3FM PROJECT

RFI Response Report

Case Reference PA29N.320250 / ABP-320250-24

MH19016N
3FM Project
F01
1st October 2025

Figure 3-2 - Potential Alternative Route to SPAR for temporary re-routing of HGV traffic from South Bank Road between 2036 and 2039 (can be discussed with DCC)

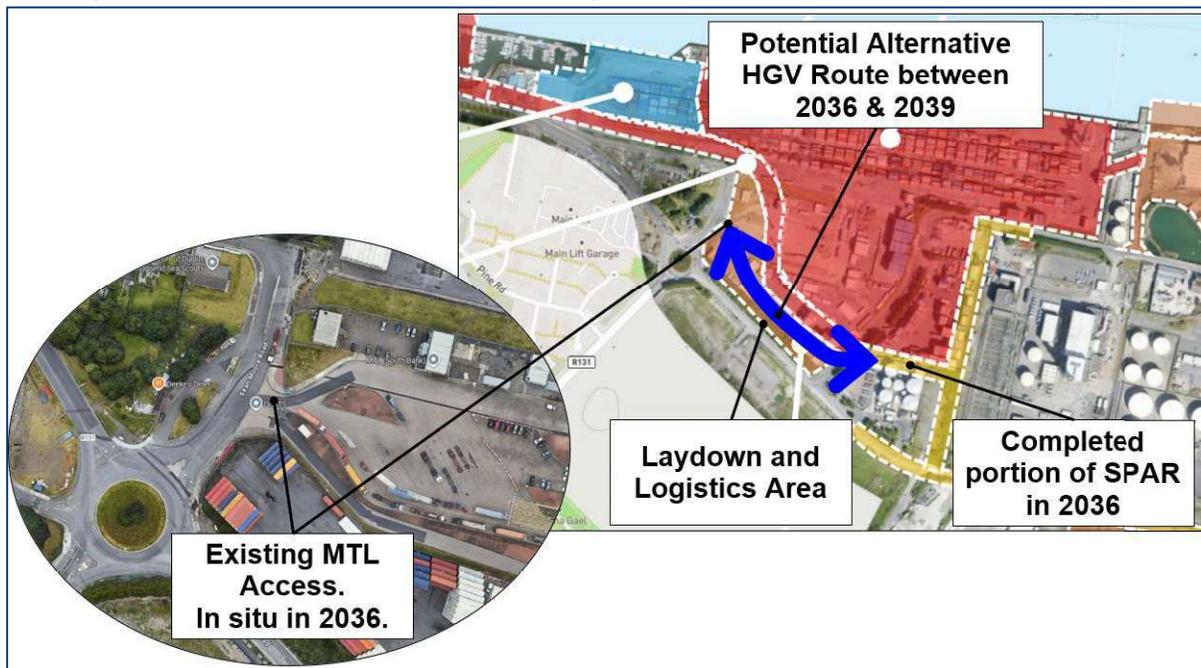
“It is stated in the applicant’s sequencing programme (figure 5.31 of chapter 5 to volume II and appendix 5.4 of the submitted Environmental Impact Assessment Report) that the proposed piled-deck, Lo-Lo container terminal (Dublin Port Masterplan area N) would be operational in 2036 and the proposed southern port access route would be completed during 2039. During the intervening period (2036-2039), traffic from Poolbeg peninsula would continue to be routed via South Bank Road along with the additional traffic associated with operation of the proposed piled-deck, Lo-Lo container terminal. Section 14.11.3.1 of the applicant’s Environmental Impact Assessment Report (volume II) refers to redevelopment of the lands within the former Irish Glass Bottle and Fabrizia sites as being completed and operational in 2036, which would provide for development along the southside of South Bank Road. The applicant is requested to address this element of the proposed development in light of the potential impacts on local amenities and the provisions within the Poolbeg West Planning Scheme, including objective MV7, which aims to promote the redirection of port and port-related heavy traffic away from South Bank Road, which will be achieved through provision of an alternative route for such traffic, including HGVs, and also through traffic management, thereby ensuring a high level of amenity for those occupying non-port commercial and residential buildings.”

Notwithstanding this reduction, DPC acknowledges the objective within the Planning Scheme to provide a short term alternative route for traffic flows until the final solution for the SPAR is delivered. This alternative route would reduce port-related traffic along South Bank Road during the construction phase thereby resulting in a further reduction than that already expected due to the staggered construction of the 3FM Project and net traffic reduction.

During this period construction vehicles will be managed in accordance with the Construction Environmental Management Plan and Construction Traffic Management Plan which will be discussed with DCC. As part of the Traffic Management Plan discussions, DPC will liaise with DCC in relation to traffic management in this area during 2036 to 2039 and agree traffic management routing for HGVs to contribute towards the reduction in traffic flows along South Bank Road until the SPAR is open in 2039.

A suggested route is shown below which makes use of the existing MTL site access and a constructed section of SPAR in 2036, via the proposed logistics area, allowing port related traffic to bypass South Bank Road. The image shown in **Figure 3-2** below is taken from the proposed construction phasing (EIAR Vol 3 Appendix 5.4 Construction Sequencing Programme). The yellow hatching indicates the completed road network by 2036.

Problem No.2: Pedestrian Crossing Width and Refuge

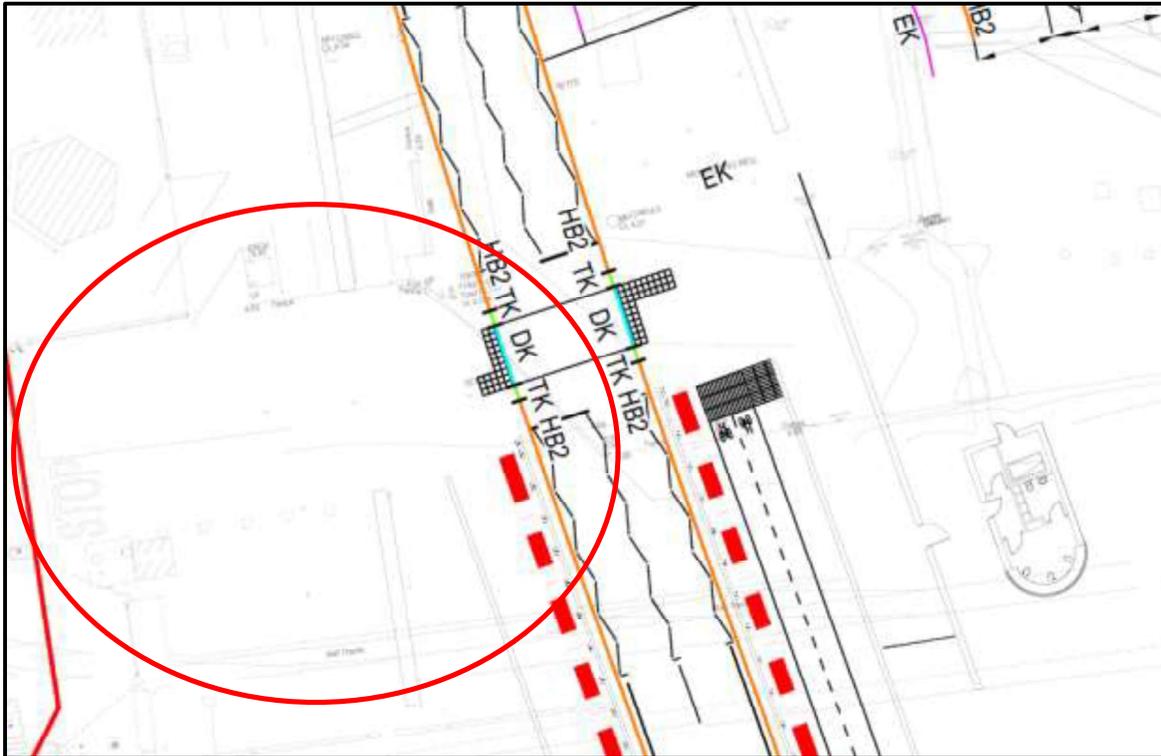
The audit team note that the proposed pedestrian crossing point width at the junction is very wide, and the audit team are concerned that this could expose vulnerable users to potential conflicts with vehicles. The audit team are concerned that with the volume of large turning vehicles that this crossing point could create a hazard for vulnerable users if appropriate refuge facilities are not provided.

Location: Bridge Crossing Point and Footpath Crossing (S26-HGN-XX-DR-HE-100-0003)

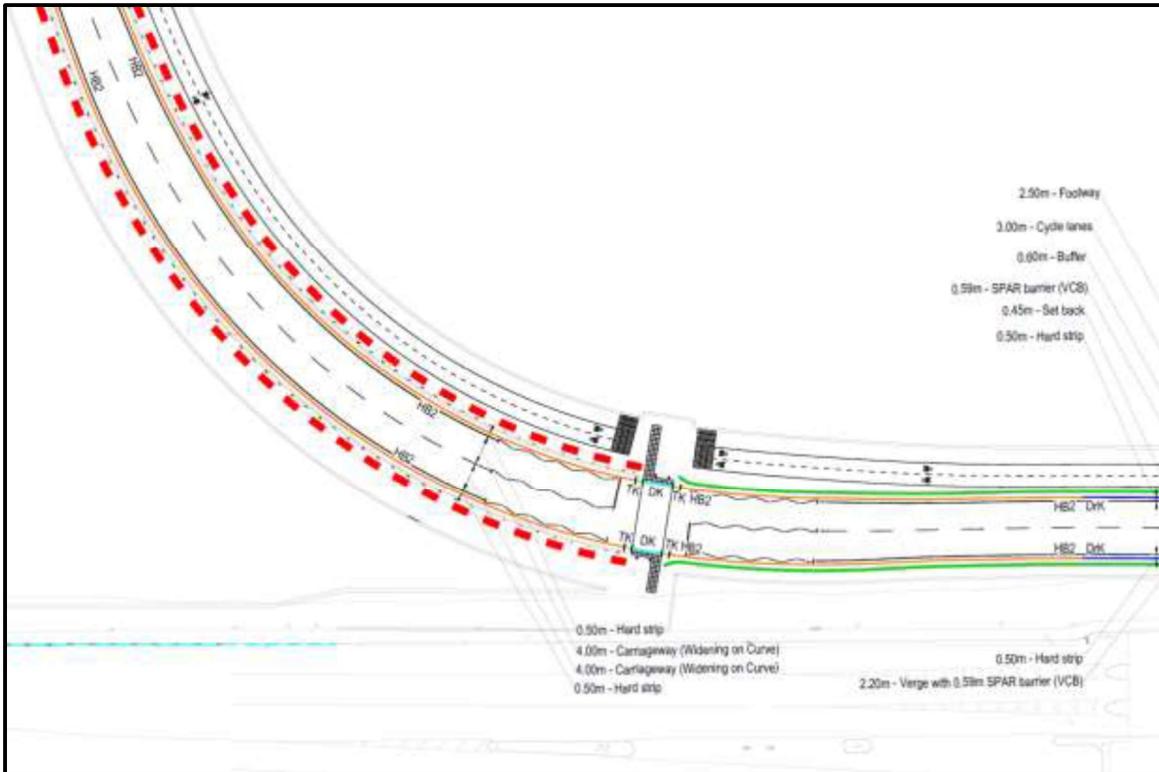
The audit team note that there is a lack of detail provided on pedestrian safeguarding across the proposed bridge and on the proposed footpath tying into the existing footpath facilities on the on the R131. The absence of appropriate pedestrian guard railing or similar across the river could result in vulnerable users falling into the river which could result in drowning incidents.

Location: Existing Access Points (S26-HGN-XX-DR-HE-100-0007)

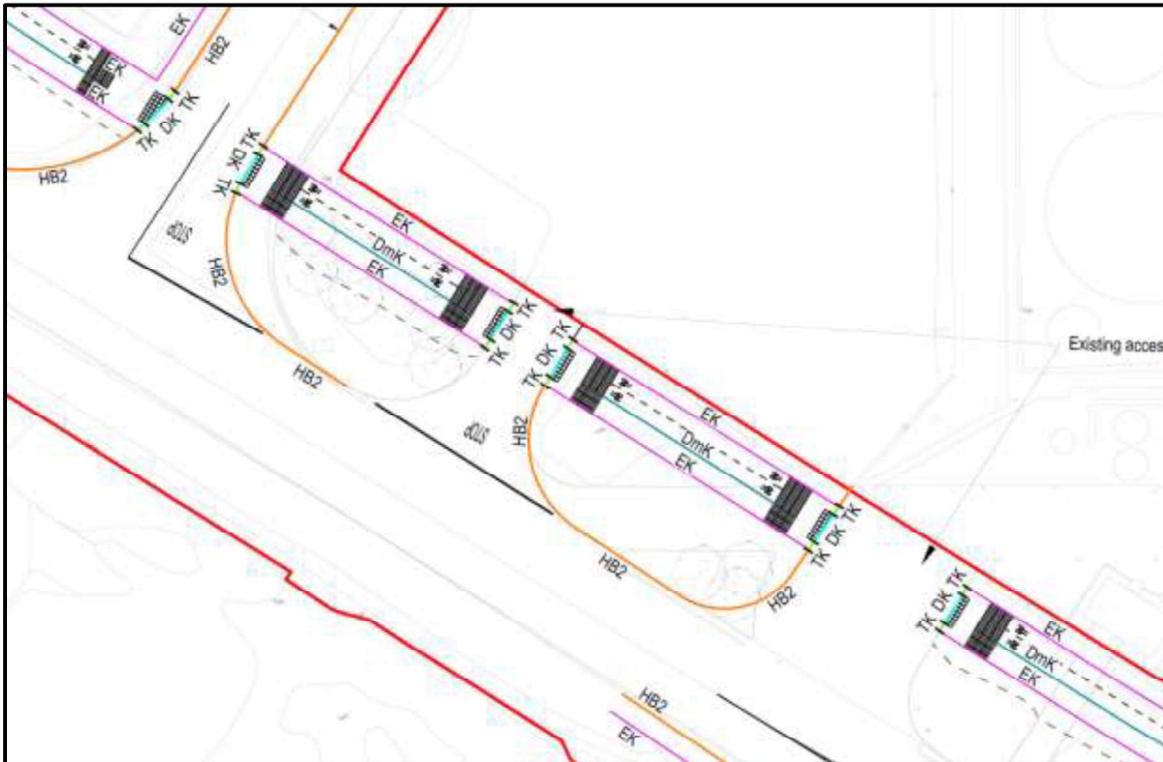
The audit team note from the proposals that it is intended to retain most of the access points at the identified location. The audit team is concerned that the number of accesses will increase the potential for vulnerable user conflicts with vehicles. The risk will be increased further due to the increased volume of vulnerable users that will utilise the scheme once built. The audit team also note that the number of conflict points also increases the likelihood of increased vehicle conflicts.

Location: New Junction (S26-HGN-XX-DR-HE-100-0007)

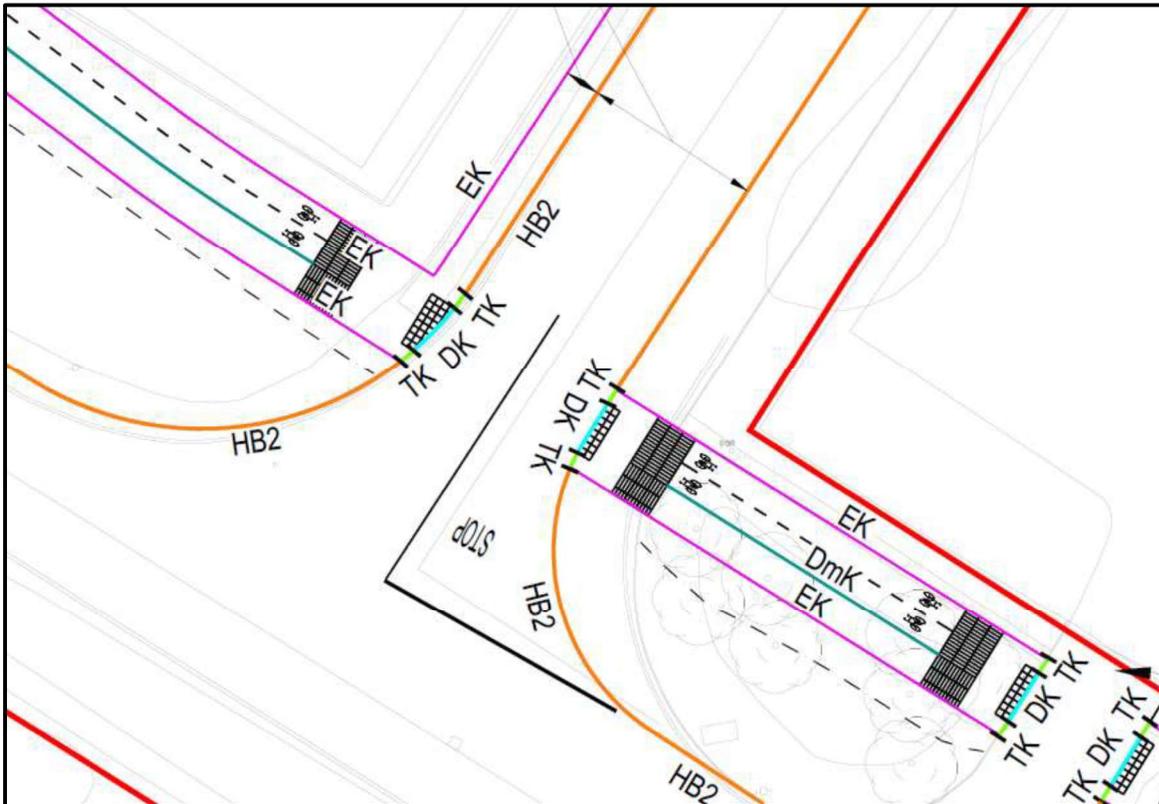
The audit team note that there is existing landscaping at the identified junction that will need to be removed to achieve the required sightlines from this junction. The drawings do not detail the sightline availability at the junction and the audit team are concerned that the required sightlines may not be achievable without the removal of the existing landscaping/scrub area. There are also no proposals to remove this landscaping as part of the works. The lack of appropriate visibility at this junction will increase the safety risk for exiting vehicles.

Location: Existing Access Point (S26-HGN-XX-DR-HE-100-0008)

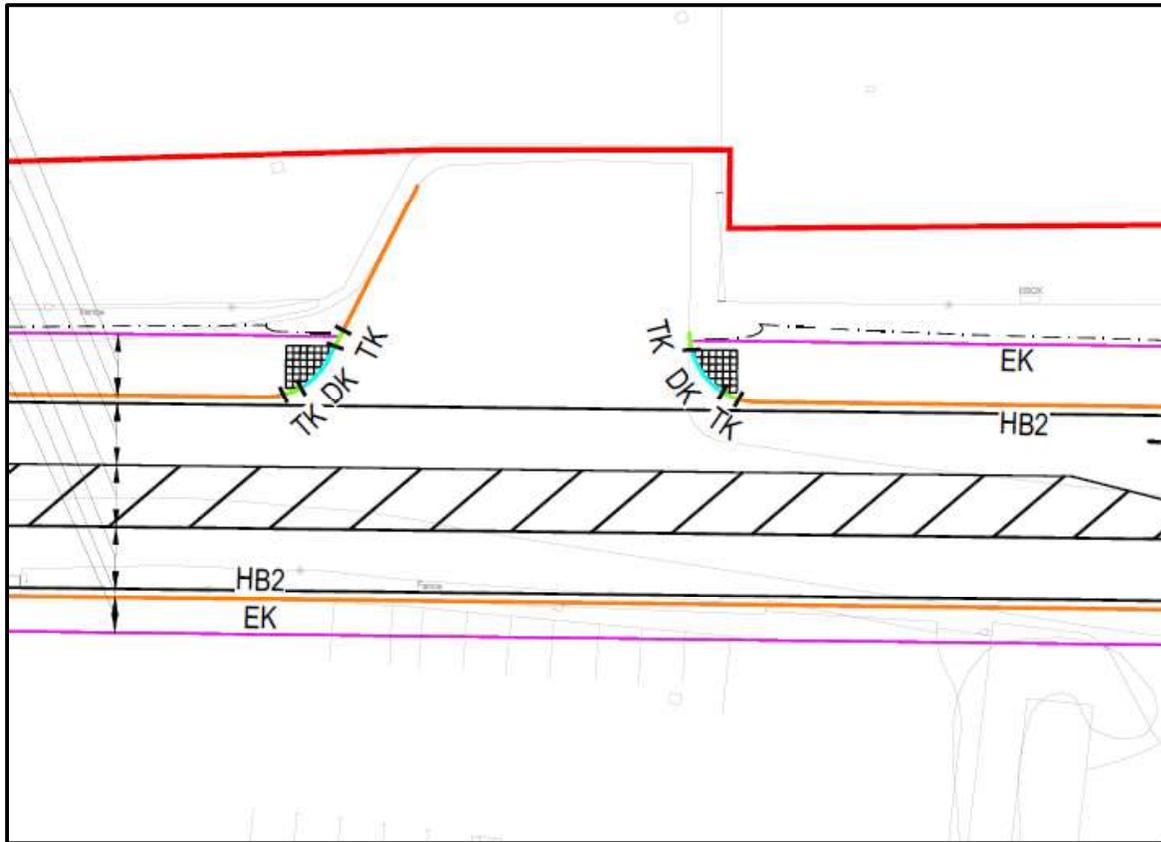
The audit team note that the proposed pedestrian crossing point width at the identified junction is wide, and the audit team are concerned that this could expose vulnerable users to potential conflicts with vehicles. The audit team are concerned that with the volume of large turning vehicles that this crossing point could create a hazard for vulnerable users if appropriate refuge facilities are not provided. The audit team are also concerned about the orientation of the existing access point and how it ties into the main carriageway. The orientation could restrict visibility for exiting vehicles which could increase the likelihood of conflicts with both vulnerable users and vehicles on the main carriageway.

Location: Proposed Access Point (S26-HGN-XX-DR-HE-100-0009)

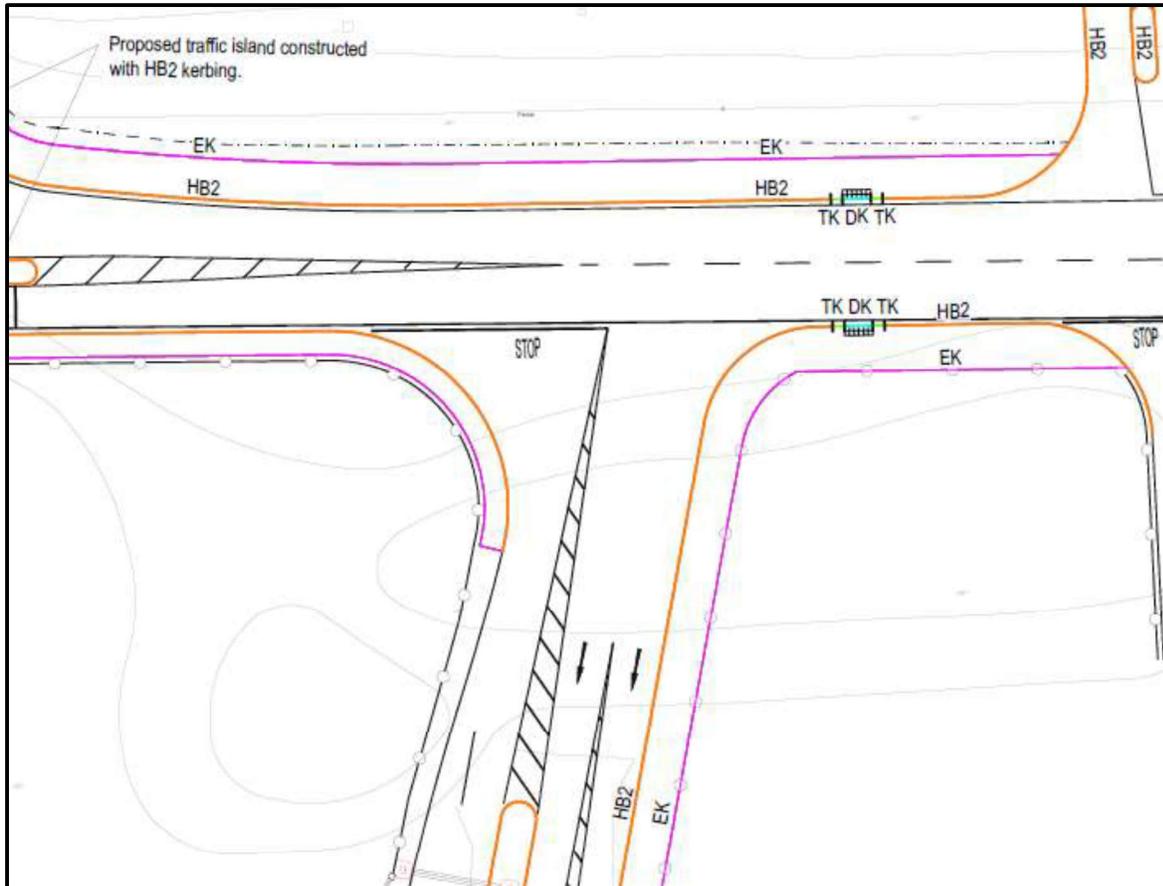
The audit team note that the junction does not detail pedestrian crossing facilities at the junction. The lack of vulnerable user crossing facilities at the junction could result in vulnerable users crossing at undesignated locations. This could potentially result in conflicts with vehicles and or trip and falls.

Location: New Access Road (S26-HGN-XX-DR-HE-100-0009)

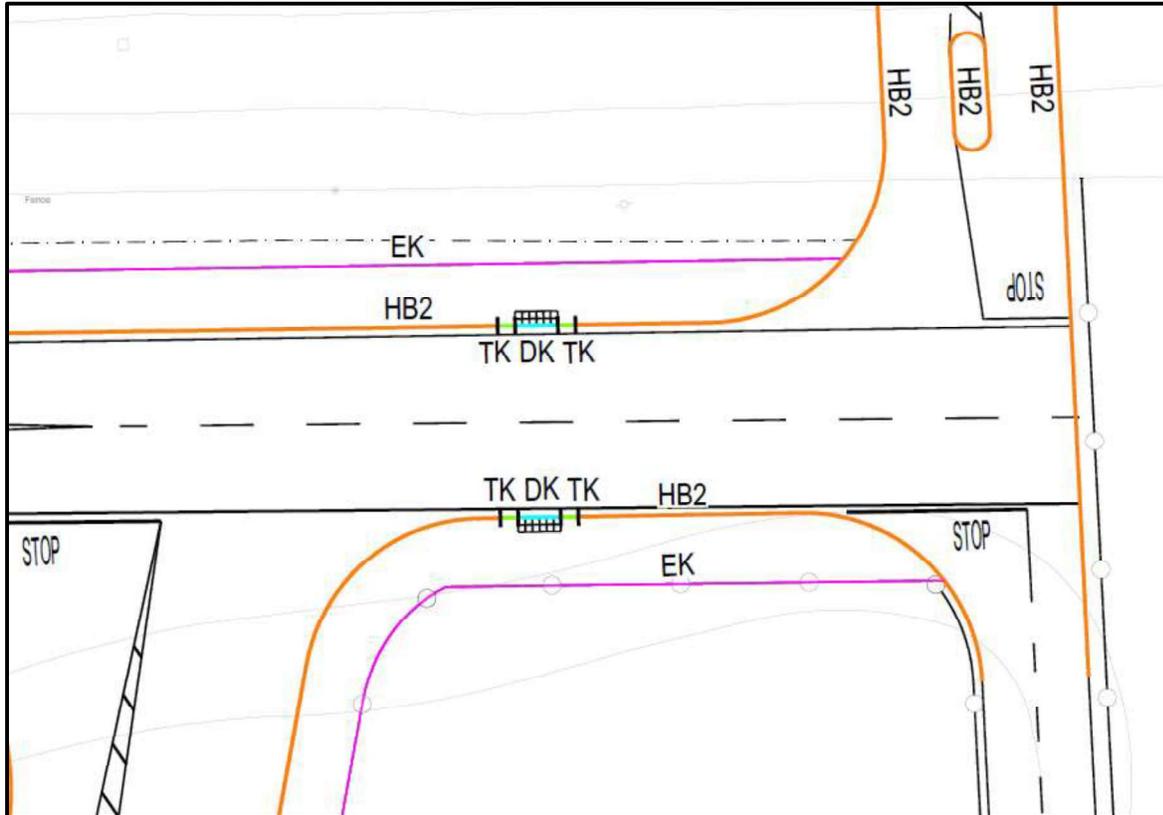
The audit team note that the proposed pedestrian crossing point width at the identified location is very wide, and the audit team are concerned that this could expose vulnerable users to potential conflicts with vehicles. The audit team are concerned that this crossing point could create a hazard for vulnerable due to the excessive width that vulnerable users must travel to cross the road.

Location: Existing Celtic Anglian Access (S26-HGN-XX-DR-HE-100-0012)

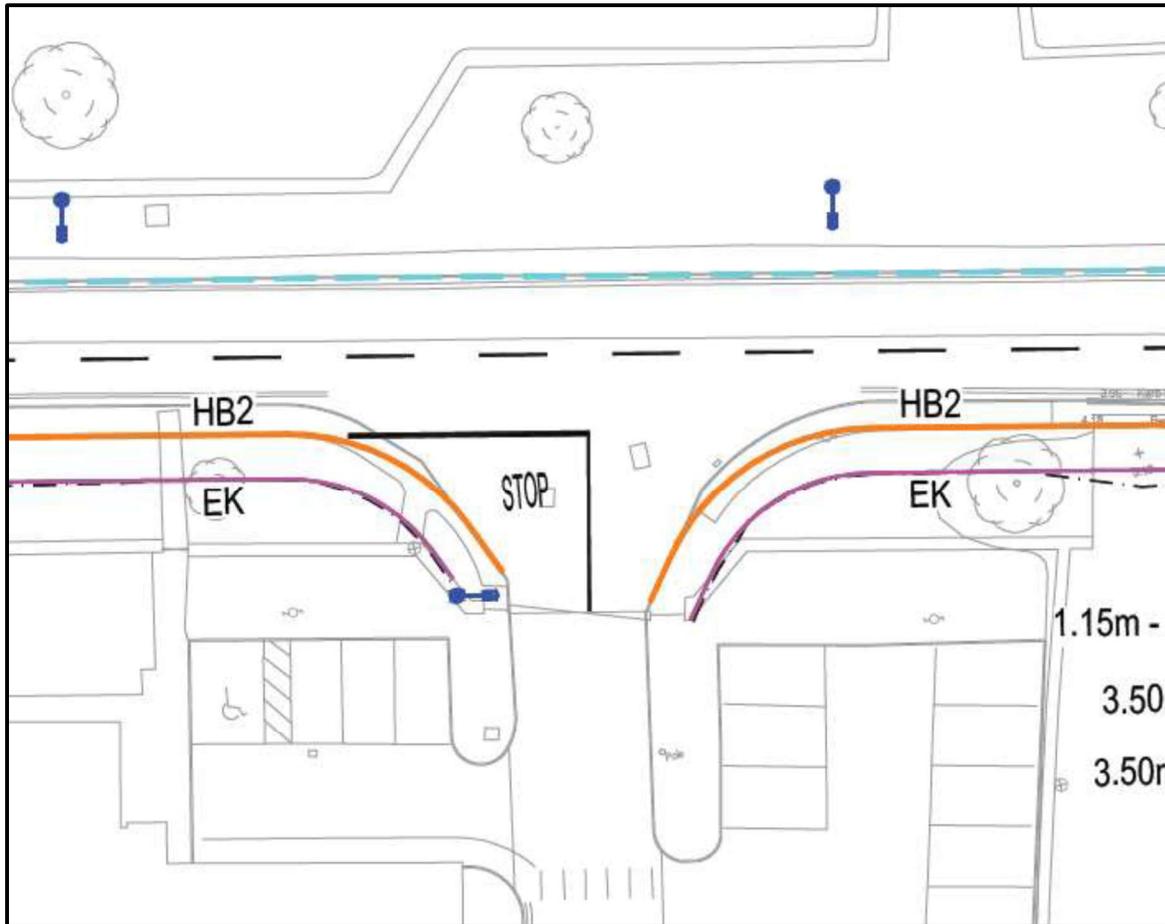
The audit team note that there are no proposals to include for an appropriate crossing point at the existing access identified. The lack of appropriate dropped kerbing and tactile paving could increase the risk of trip and falls among vulnerable users.

Location: Existing Irish Water Treatment Plant (S26-HGN-XX-DR-HE-100-0013)

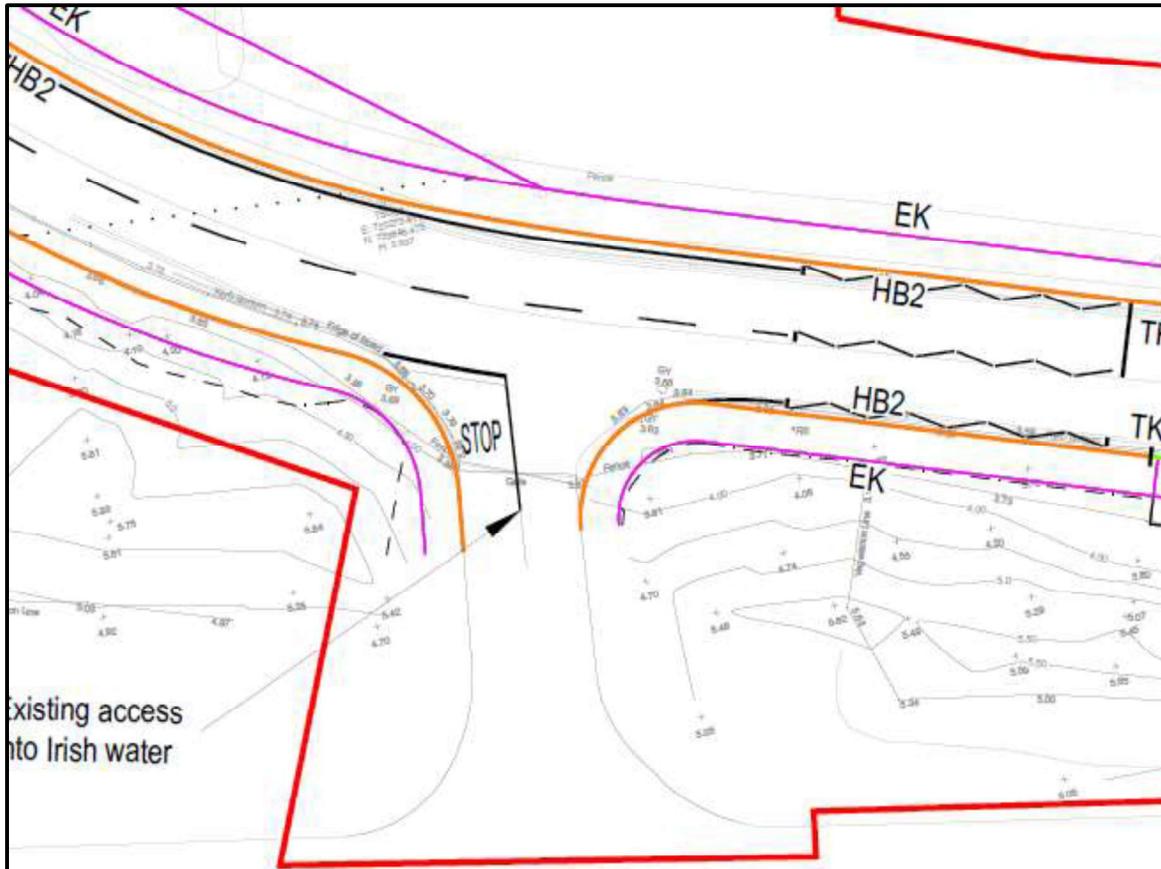
The audit team note that there are no proposals to include for an appropriate crossing point at the existing access identified. The lack of appropriate dropped kerbing and tactile paving could increase the risk of trip and falls among vulnerable users.
